SECTION 96 SUBMISSION

DEE WHY RSL CLUB - 932 PITTWATER ROAD  
STAGE 5 CLUB EXTENSION

3 CAR PARK LEVEL 1 (ENTRY LEVEL)  
Scale: 1:200

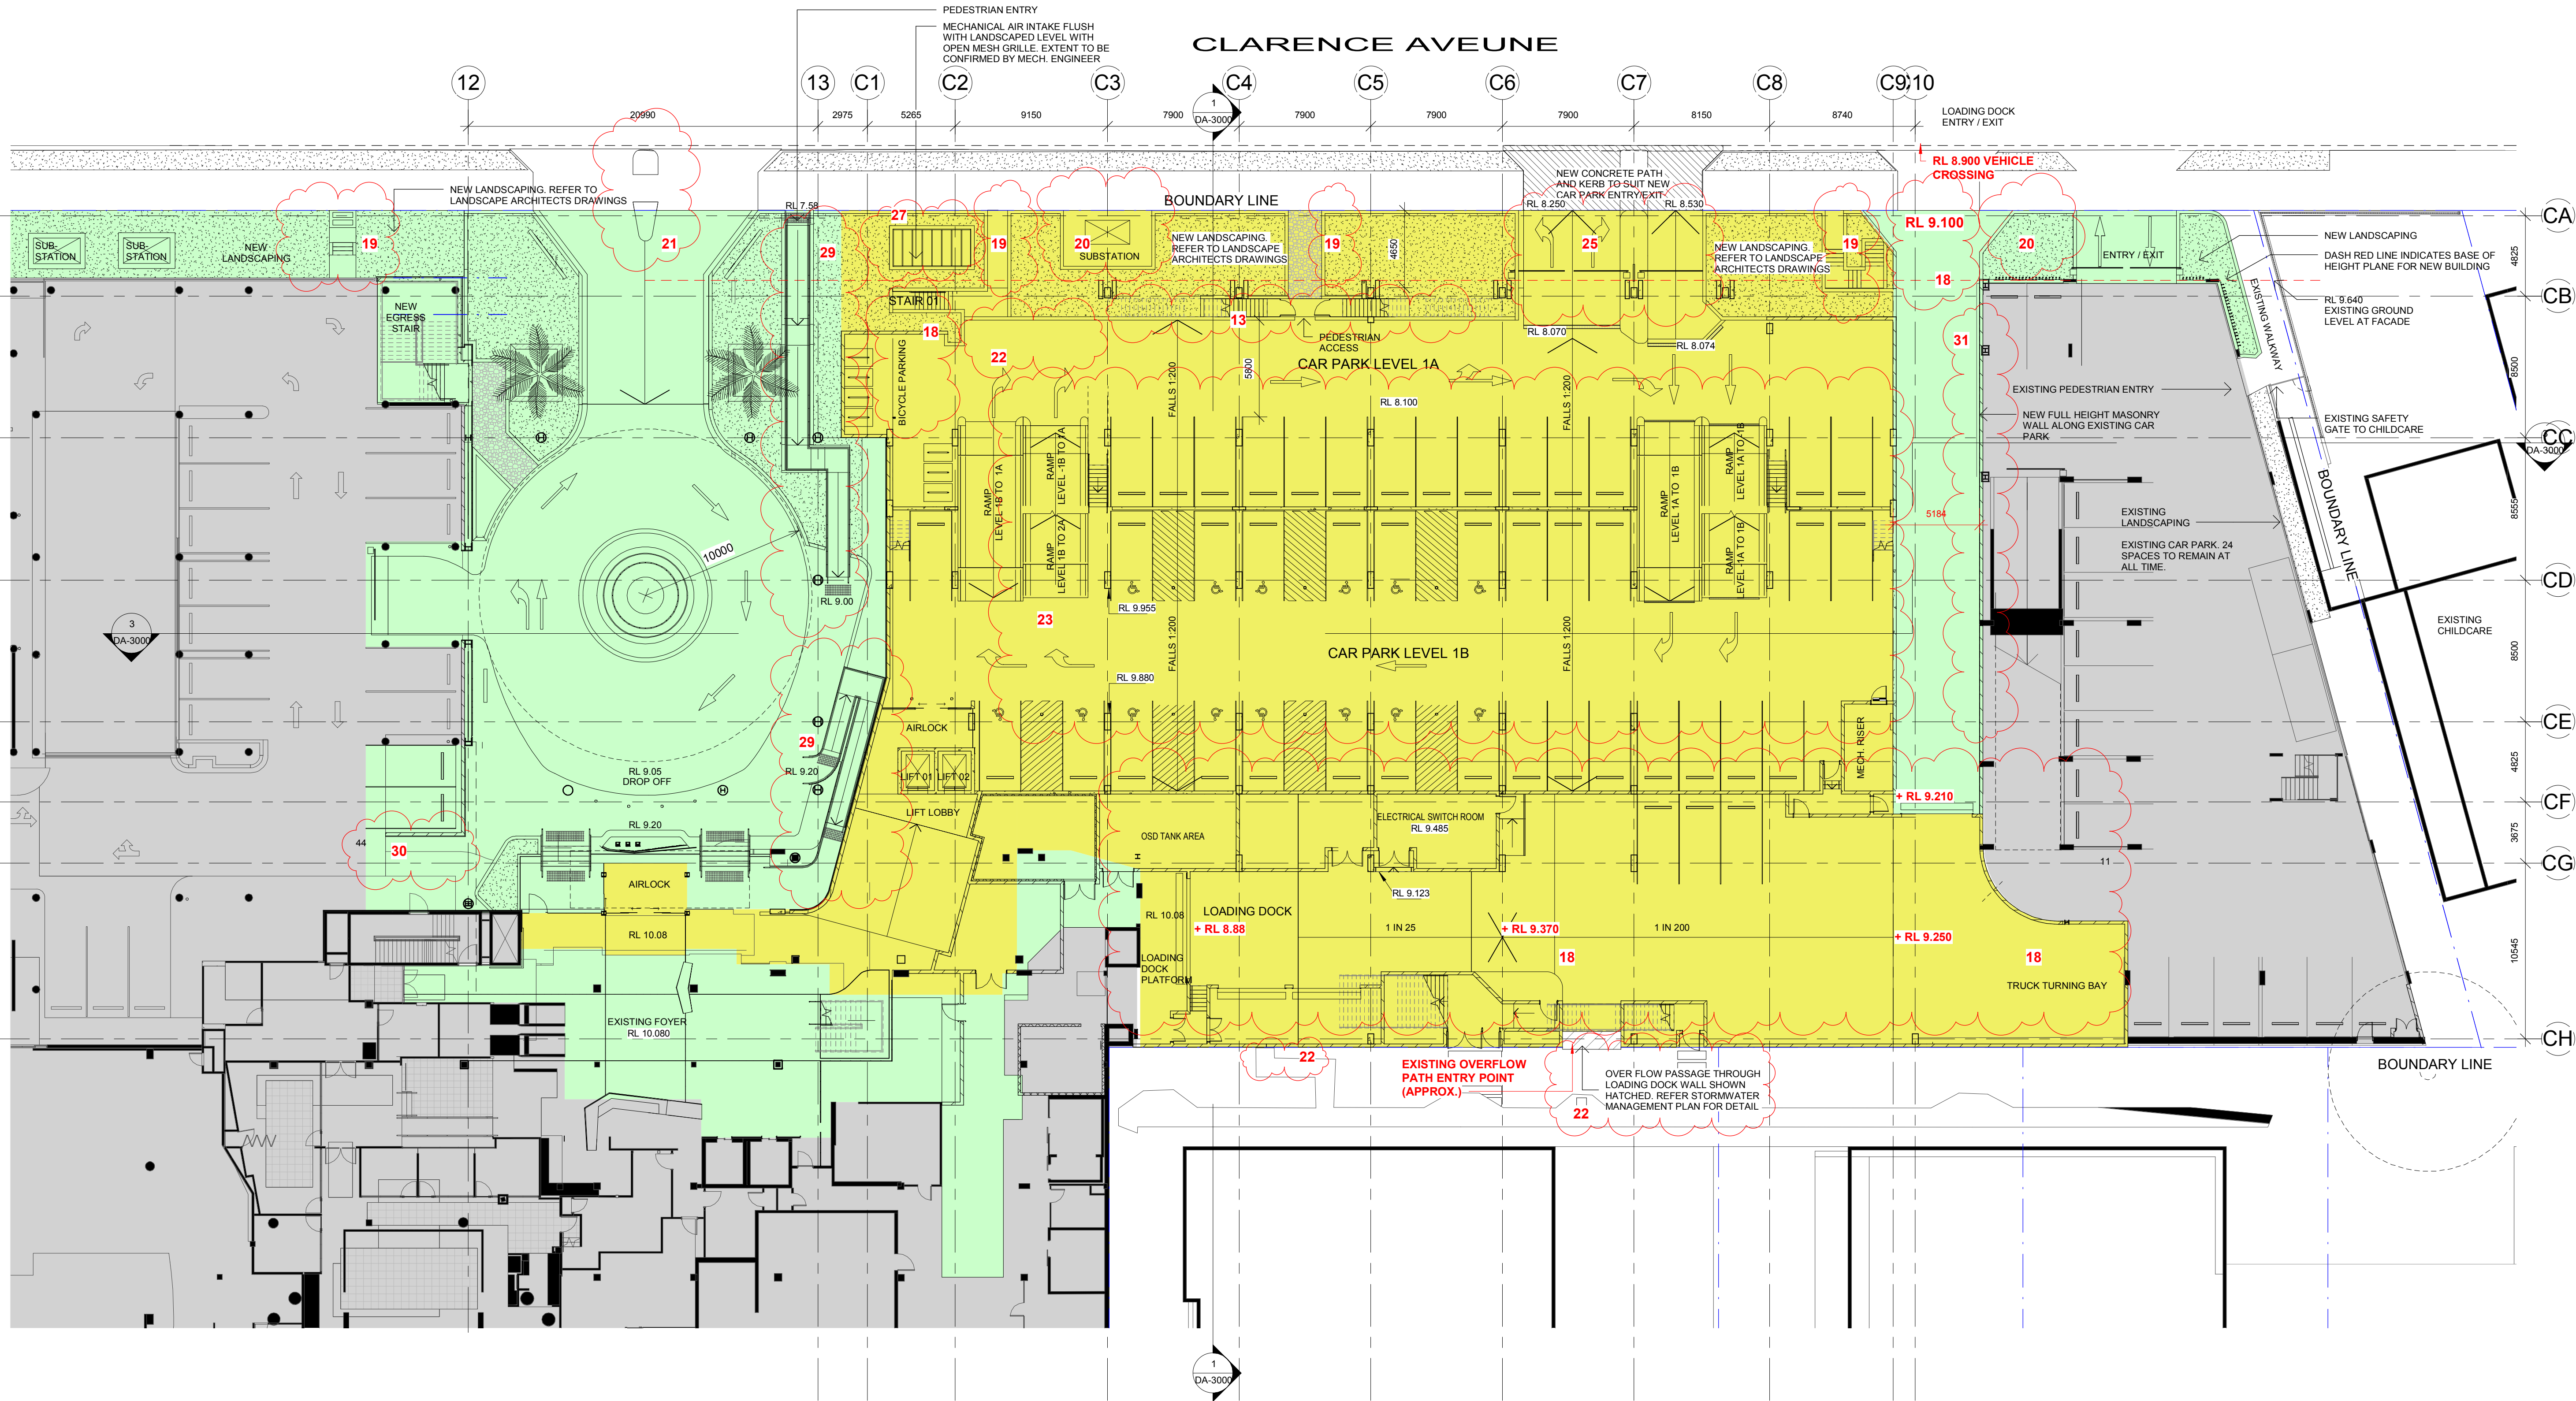
1. RELOCATED OPEN PLANTROOM AT THE ROOF LEVEL

2. MODIFIED ROOF OPENING ABOVE MAIN ENTRANCE

3. MODIFIED CENTRAL SKYLIGHT (REDUCED HEIGHT, MODIFIED PITCH)

4. MODIFIED COURTYARD: TWO OPEN COURTYARDS AND ONE SKYLIGHT COVERED AREA INSTEAD OF ONE LARGE GLASS ROOF, REDUCED HEIGHT AND PITCH

5. MODIFIED SMOKING TERRACE: ROOF OPENING, SIZE AND PLANTED AREA. AREA REDUCED BY 21m<sup>2</sup>

7. MODIFIED EXIT STAIR: POSITION, CONFIGURATION, METAL ROOF NO LONGER REQUIRED

10. NEW ACOUSTIC METAL ROOF ABOVE REVISED LOADING DOCK

11. MODIFIED FACADE APPEARANCE DUE TO CHANGES IN THE CAR PARK LEVELS, LOADING DOCK AND EGRESS STAIRS

12. REMOVED LOUVRES ON THE BACK FACADE (WESTERN FACADE) DUE TO MECHANICAL RISER NO LONGER REQUIRED / REVISED LOCATION FOR EGRESS DOORS

13. 2m WIDE INTERNAL EGRESS STAIR MODIFIED INTO TWO 1m WIDE EXTERNAL STAIRS WITH DECORATIVE BALUSTRADES

15. MODIFIED FACADE CURTAIN WALL MULLION BLADES

18. REVISED LOADING DOCK ENTRANCE AND LOCATION/ ENLARGED DEMOLISHED AREA IN THE EXISTING RETAINED SOUTHERN CAR PARK

19. NEW / MODIFIED EGRESS PATHS FROM EXISTING CARPARK LEVEL -1. NEW CARPARK LEVEL 1.

21. MEDIAN STRIP ADDED AT ENTRY TO PROVIDE PLACE OF REFUGE AND ENSURE WIDTH OF ENTRY/ EXIT IS LESS THAN 8M AS PER DA CONDITION 23

24. BASEMENT CAR PARK LEVEL -5 ADDED.

26. PLANTER MODIFIED ON THE BACK (WESTERN) FACADE DUE TO REDUCTION OF THE MAIN TRADING FLOOR SLAB

27. LOCATION OF AIR INTAKE MODIFIED

29. CLUB ENTRANCE ACCESSIBLE RAMPS MODIFIED

31. FULL HEIGHT SOLID MASONRY WALL ADDED BETWEEN EXISTING ZONE D CAR PARK AND LOADING DOCK ACCESS.

DRAWING TITLE:  
PROPOSED LEVEL 2 SOUTH EAST  
LEVEL 3 AND LEVEL 4

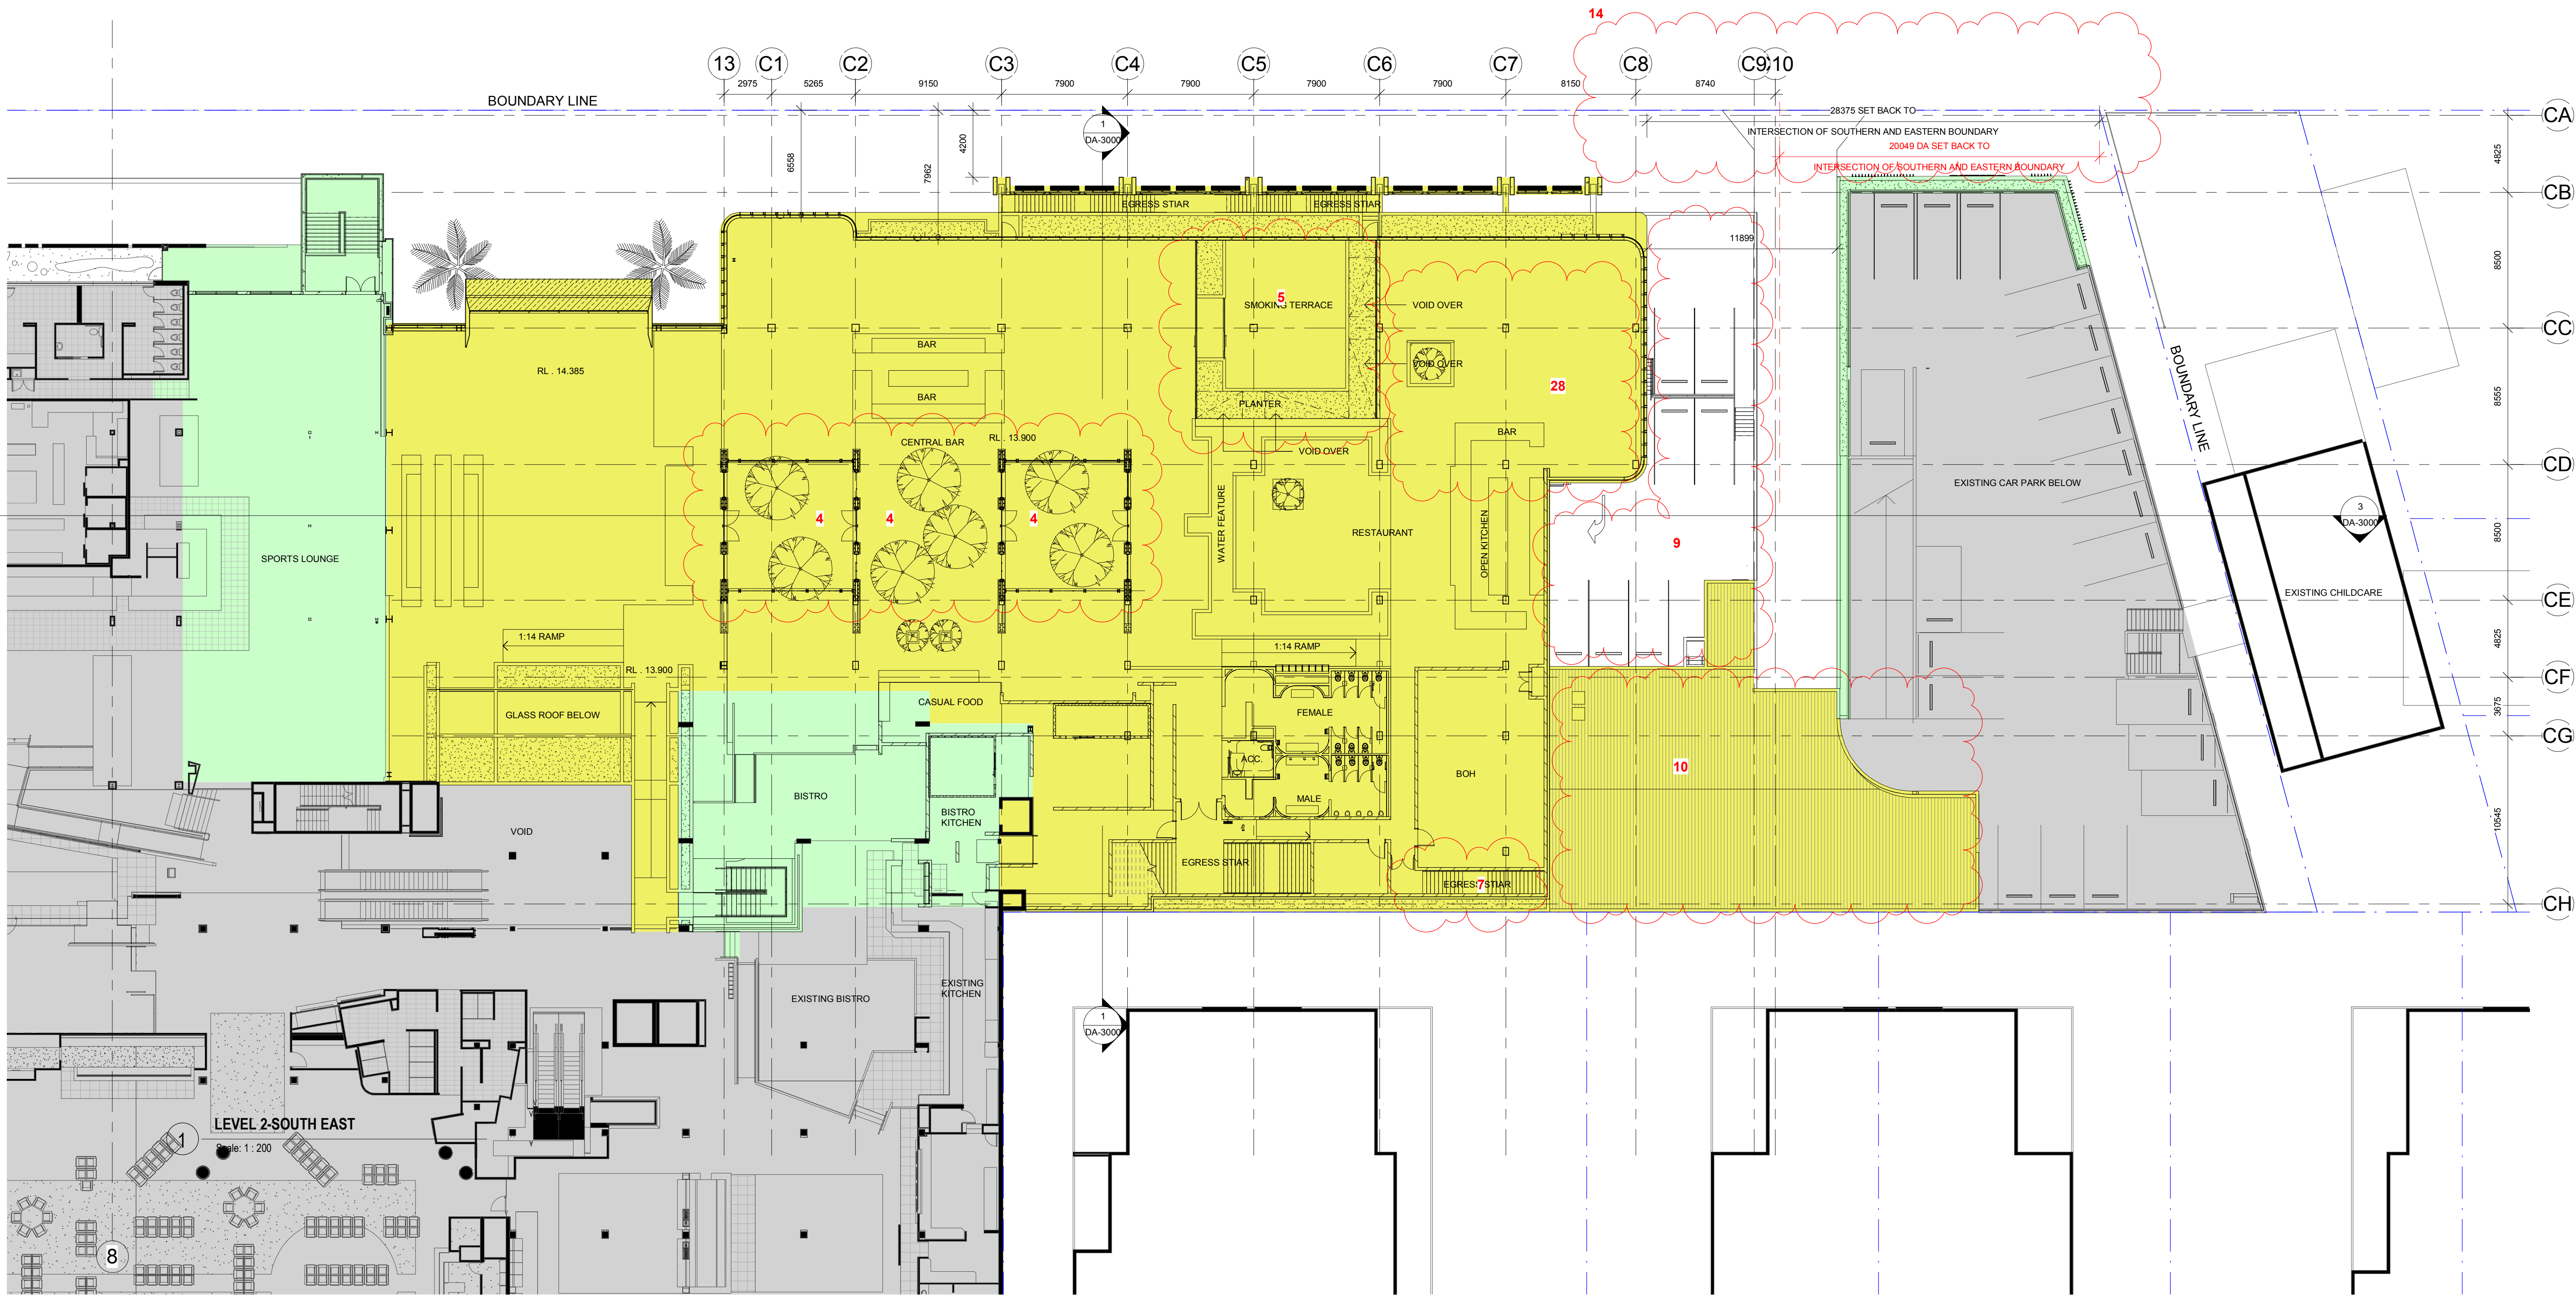
1. RELOCATED OPEN PLANTROOM AT THE ROOF LEVEL
2. MODIFIED ROOF OPENING ABOVE MAIN ENTRANCE
3. MODIFIED CENTRAL SKYLIGHT (REDUCED HEIGHT, MODIFIED PITCH)
4. MODIFIED COURTYARD: TWO OPEN COURTYARDS AND ONE SKYLIGHT COVERED AREA INSTEAD OF ONE LARGE GLASS ROOF, REDUCED HEIGHT AND PITCH
5. MODIFIED SMOKING TERRACE: ROOF OPENING, SIZE AND PLANTED AREA, AREA REDUCED BY 21m<sup>2</sup>
6. REDUCED NUMBER OF ROOF SKYLIGHTS ABOVE ASIAN RESTAURANT, 2 INSTEAD OF 6 TO SUIT THE NEW INTERNAL LAYOUT
7. MODIFIED EXIT STAIR: POSITION, CONFIGURATION, METAL ROOF NO LONGER REQUIRED
8. CONCRETE ROOF INSTEAD OF METAL DECK ROOF FOR THE MAJORITY OF THE BUILDING EXTENSION
9. NO SLAB ABOVE THE EXPOSED CAR PARK LEVEL 2 IN THE SOUTH AREA
10. NEW ACOUSTIC METAL ROOF ABOVE REVISED LOADING DOCK

11. MODIFIED FACADE APPEARANCE DUE TO CHANGES IN THE CAR PARK LEVELS, LOADING DOCK AND EGRESS STAIRS
12. REMOVED LOUVRES ON THE BACK FACADE (WESTERN FACADE) DUE TO MECHANICAL RISER NO LONGER REQUIRED / REVISED LOCATION FOR EGRESS DOORS
13. 2m WIDE INTERNAL EGRESS STAIR MODIFIED INTO TWO 1m WIDE EXTERNAL STAIRS WITH DECORATIVE BALUSTRADES
14. EXTENT OF LEVEL 2 (MAIN TRADING LEVEL) REDUCED BY 838mm FROM THE SOUTHERN BOUNDARY AND INCREASED BY 1100mm TO THE EASTERN BOUNDARY
15. MODIFIED FACADE CURTAIN WALL MULLION BLADES
16. CONCRETE BLADE WALL REDUCED BY 1.47m IN HEIGHT AND 6.2m IN LENGTH
17. VERTICAL FINIS REMOVED FROM BACK WALL (WESTERN FACADE)

18. REVISED LOADING DOCK ENTRANCE AND LOCATION, ENLARGED DEMOLISHED AREA IN THE EXISTING RETAINED SOUTHERN CAR PARK
19. NEW / MODIFIED EGRESS PATHS FROM EXISTING CARPARK LEVEL -1, NEW CARPARK LEVEL 1

20. RELOCATED ELECTRICAL SUBSTATION / LANDSCAPED AREA MOVED TO SUIT
21. MEDIAN STRIP ADDED AT ENTRY TO PROVIDE PLACE OF REFUGE AND ENSURE WIDTH OF ENTRY/ EXIT IS LESS THAN 8M AS PER DA CONDITION 23

24. BASEMENT CAR PARK LEVEL -5 ADDED
25. CAR PARK ENTRY / EXIT MOVED TOWARD NORTH BY 3044mm
26. PLANTER MODIFIED ON THE BACK (WESTERN) FACADE DUE TO REDUCTION OF THE MAIN TRADING FLOOR SLAB

27. LOCATION OF AIR INTAKE MODIFIED
28. EXTENT OF RESTAURANT REDUCED BY 136m<sup>2</sup>
29. CLUB ENTRANCE ACCESSIBLE RAMPS MODIFIED
30. ONE ADDITIONAL EXISTING CAR PARK SPACE TO BE REMOVED FROM EXISTING NORTHERN CAR PARK

31. SOLID MASONRY WALL ADDED BETWEEN EXISTING ZONE D CAR PARK AND LOADING DOCK ACCESS.
